For concrete plank construction at a fire rated wall:

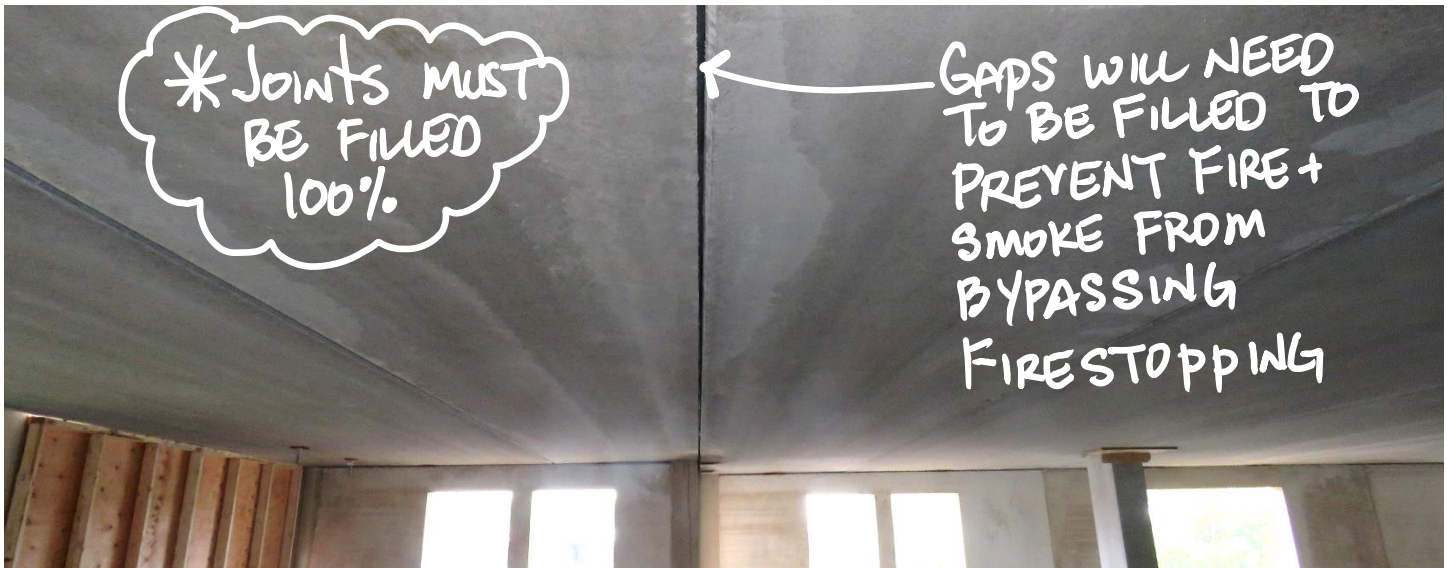
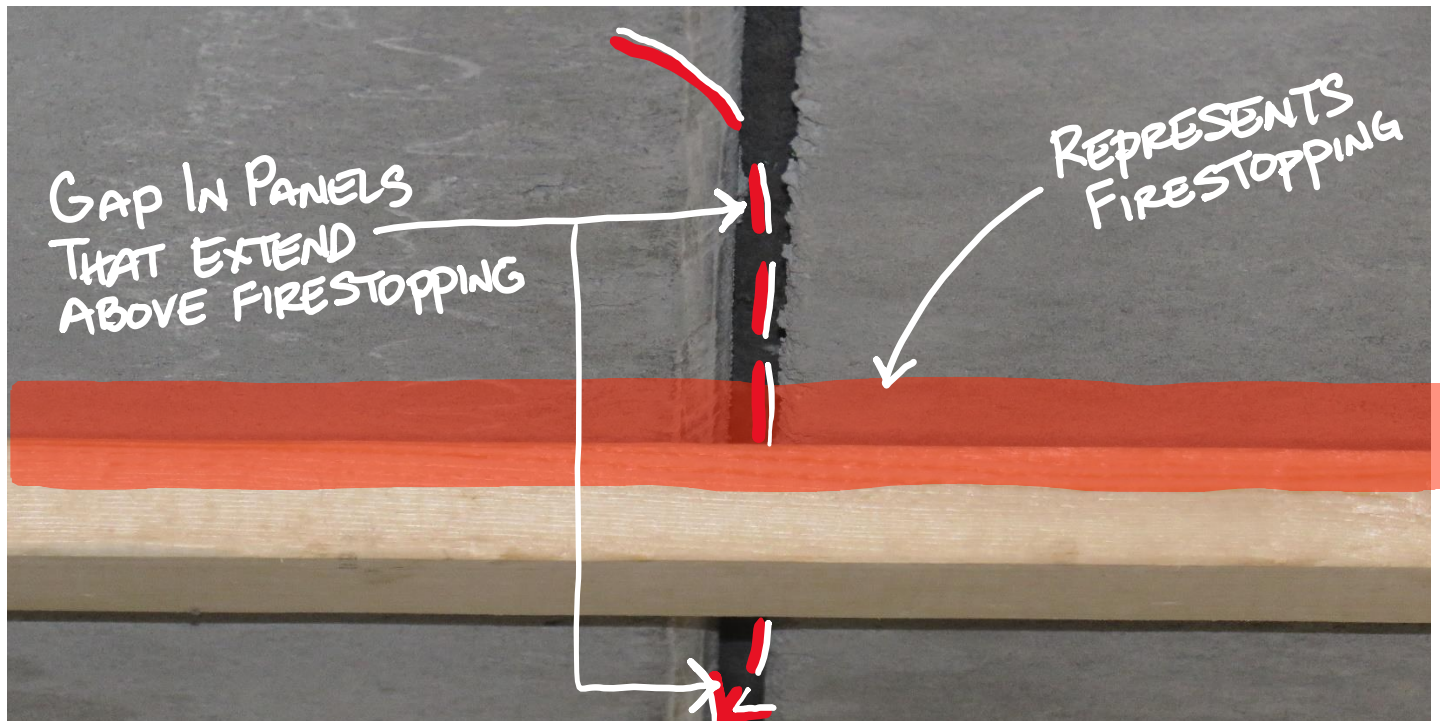
There are gaps installed in the precast planks that will be a fire and smoke passageways on either side of the fire rated wall.

The gaps need to be treated, 100% of the length of the panel

We cannot just seal the joint at the wall...this will not stop the passage above the firestopping.

This is a concern that needs to be discussed and accounted for during bidding on how to manage these joints on the underside if we have fire rated walls.
